PERMIT APPLICATION FOR A RESIDENTIAL SITE
IMPROVEMENT PERMIT / CONSTRUCTION AUTHORIZATION
FOR ON-SITE WASTEWATER SYSTEM
NEW WELL INSTALLATION OR REPAIR OF EXISTING WELL
MECKLENBURG COUNTY GROUNDWATER & WASTEWATER SERVICES

PLOT PLAN FOR

RE: Request for a revision to Improvement Permit for Lot 77 at The Sanctuary:
MCHD File #5486B

IMPROVEMENT PERMIT for a RESIDENTIAL ON-SITE WASTEWATER TREATMENT & DISPOSAL SYSTEM

5486B

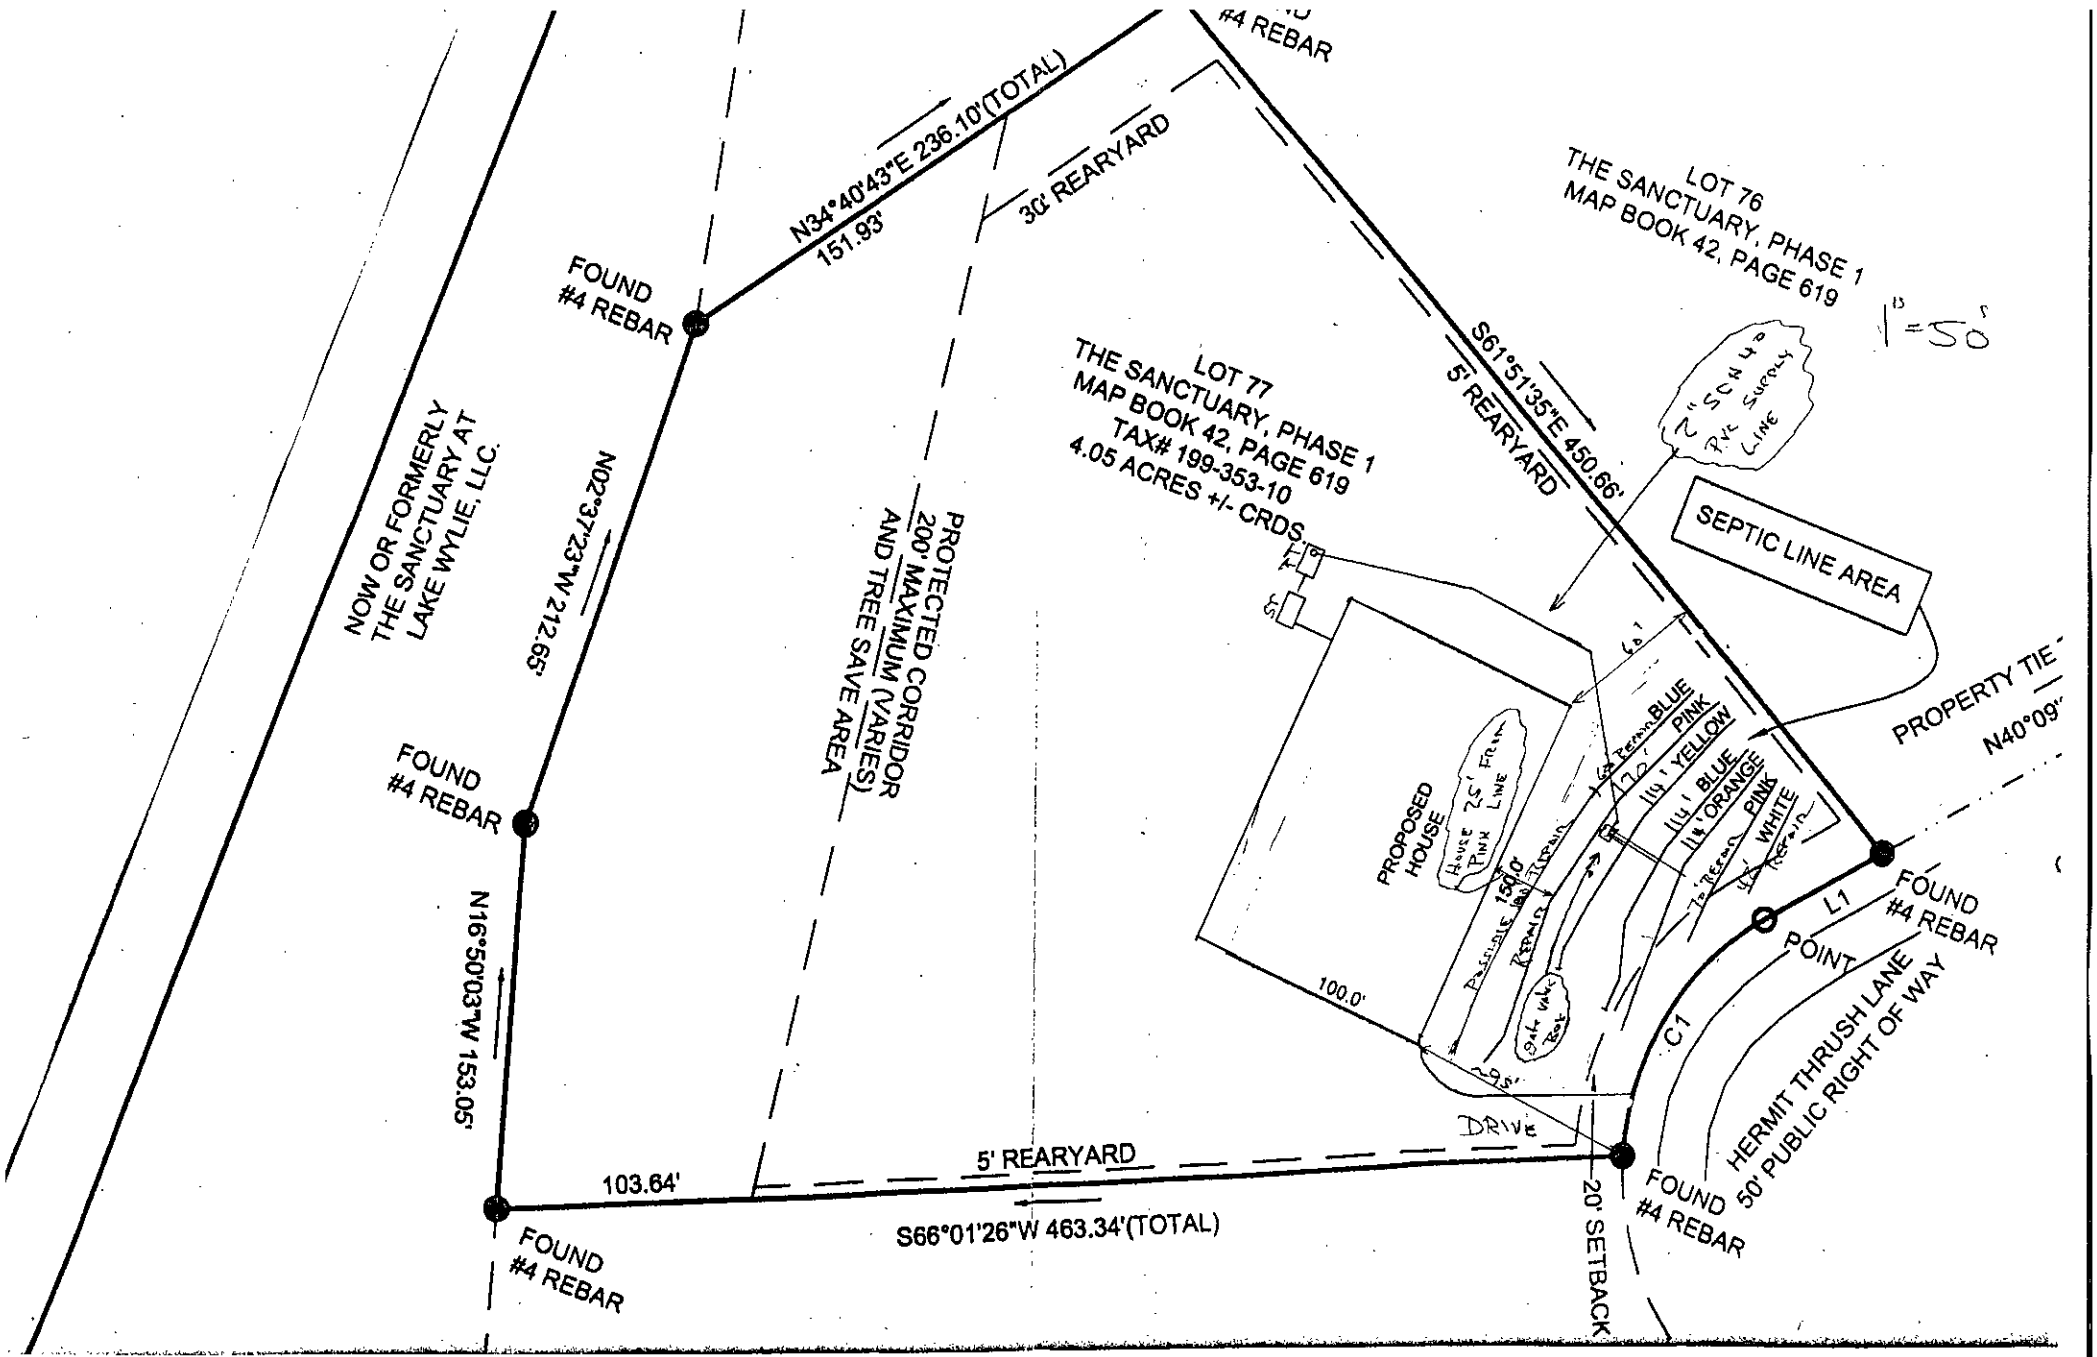
Mukesh Patel is requesting a revison to the Improvement Permit for the above referenced lot. The lot was previously permitted by The Santuary at Lake Wylie, LLC for a 5 bedroom home with a 25% reductions system with a PPBPS repair. Mr. Patel wants to move the house closer to the street and change the primary system type to a PPBPS. The system will be in the same area previously evaluated by Mr. Bill Marlin and has been approved at a 0.3 gpd/ft^2 LTAR.

The system has been re-flagged and the lines have been located by Mr. Patel's surveyor. Please review the attached site plan and system specifications for the proposed revisions to the septic system and house location. The attached sketch and specifications are not an Improvement Permit and are intended only to assist the MCHD in permitting the referenced lot at The Sanctuary.

- No work shall be conducted on the septic system until an INSTALLATION APPROVAL is granted by the Department.
- The septic system installer shall be a registered septic contractor with Mecklenburg County Health Department.
- The permitted system shall be installed in accordance with the included PLOT PLAN.
- This IMPROVEMENT PERMIT is transferable.
